PLEASANT VALLEY SUBDIVISION

APPLICATION NUMBER 11 DATE March 3, 2005
APPLICANT Pleasant Valley Subdivision
REQUEST Subdivision

PLEASANT VALLEY SUBDIVISION

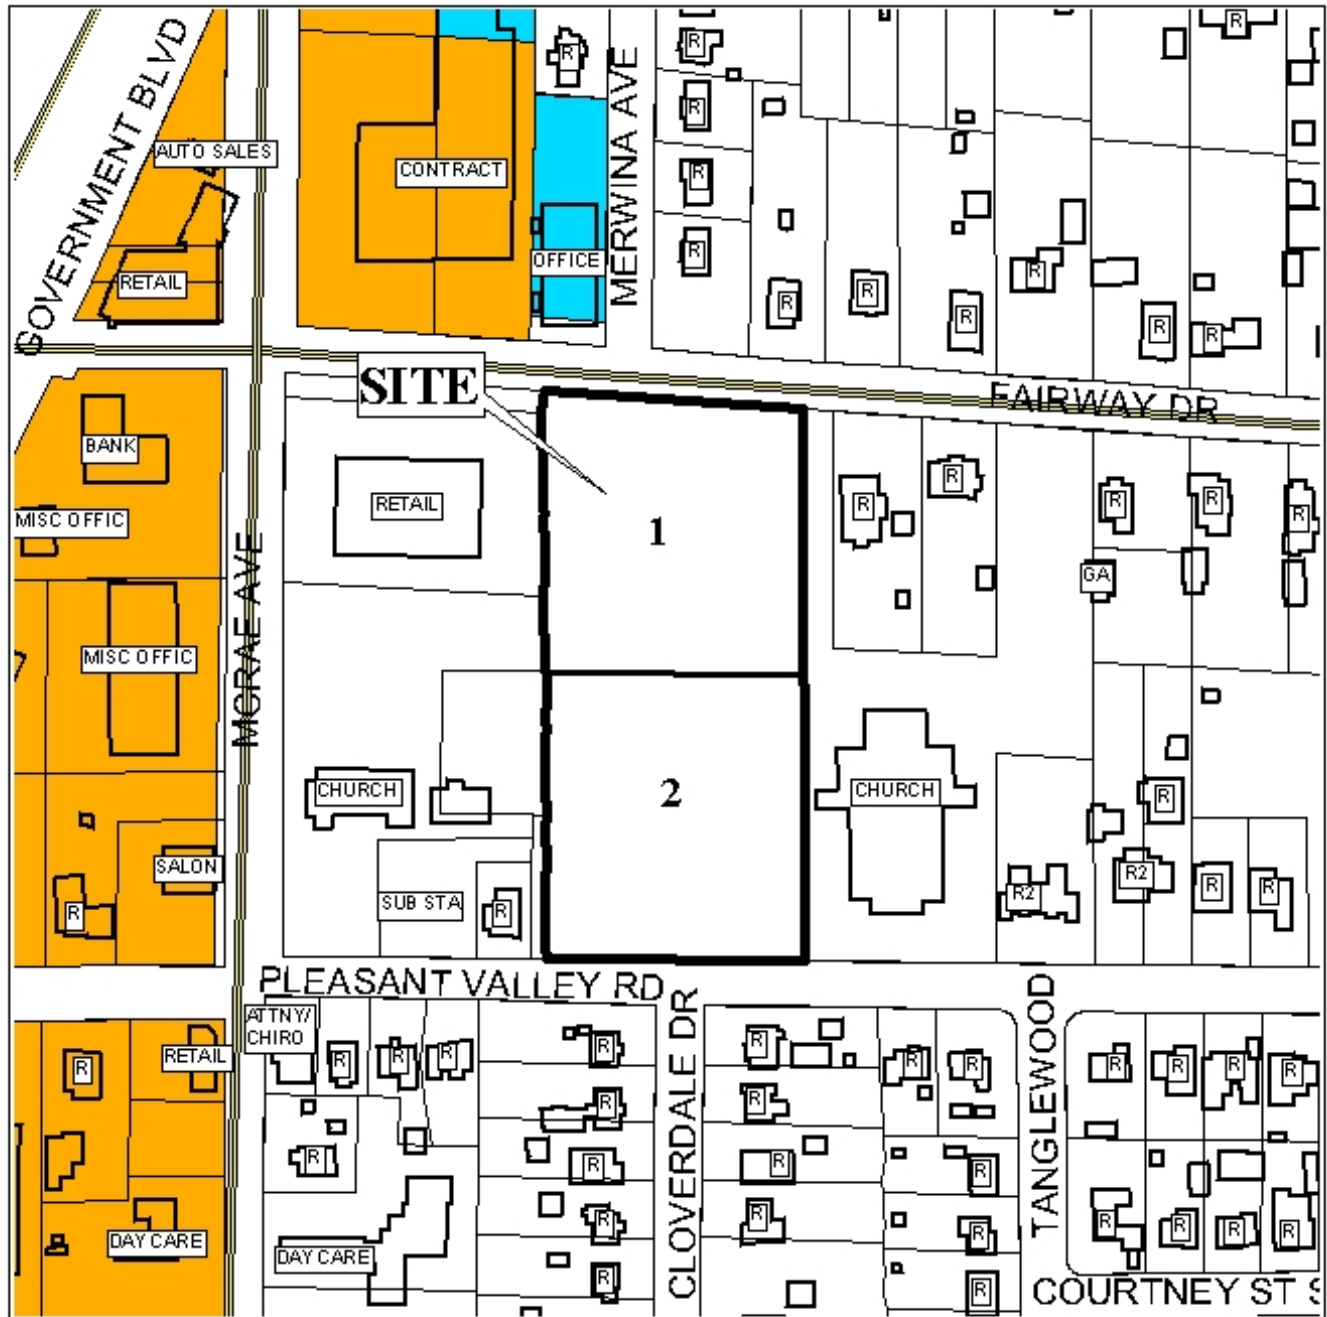
The site fronts upon two streets: Fairway Drive to the north and Pleasant Valley Road to the south. Fairway Drive is a major street, as illustrated on the Major Street Plan, and as such a minimum right-of-way width of 100 feet, or 50 feet in each direction as measured from the centerline of the roadway is required. Fairway Drive has an existing right-of-way width of 50 feet, and measures 25 feet from the roadway centerline to the property line of the proposed subdivision; thus the right-of-way width is 25 feet short of the required minimum width from the centerline for the proposed major street. The setback of an additional 25 feet of right-of-way should be required along the Fairway Drive frontage of the proposed Lot 1 in conformance with the right-of-way width requirements for future major streets in Section V.B.14. of the Subdivision Regulations.

Pleasant Valley Road's existing right-of-way of 50 feet should to be widened to 60 feet to conform to the right-of-way width requirements of Section V.B.14. for minor streets lacking curb and gutter. As such, dedication of an additional 5 feet of right-of-way should be required for the portion of the site (proposed Lot 2) abutting Pleasant Valley Road.

As the proposed Lot 1 fronts a major street, access management is a concern; therefore driveway number, sizes, location and design must be approved by Traffic Engineering and conform to AASHTO standards.

The proposed lots are 1.75 \pm acres in area, and exceed the minimum size required in Section V.D.2. for properties with public water and sanitary sewer. Both lots fall within Section V.D.3.'s recommended width to depth ratio.

The minimum building setback line required in Section V.D.9. is not shown for either lot, but would be required on the Final Plat. The building setback line should be a minimum of 25-feet

from the future right-of-way for Fairway Drive, and 25-feet from the additional dedicated right-of-way for Pleasant Valley Road.

The plat is recommended for Tentative Approval subject to the following conditions: 1) setback of an additional 25 feet of right-of-way along Fairway Drive in accordance with Section V.B.14.; 2) dedication of an additional 5 feet of right-of-way along Pleasant Valley Road in accordance with Section V.B.14.; 3) indication of the building setback line for both lots on the Final Plat, a minimum of 25-feet from the future right-of-way for Fairway Drive, and a minimum of 25-feet from the additional dedicated right-of-way of Pleasant Valley Road in accordance with Section V.D.9.; and 4) placement of a note on the Final Plat stating that curb cut number, sizes, location and design to be approved by Traffic Engineering, and conform to AASHTO standards.
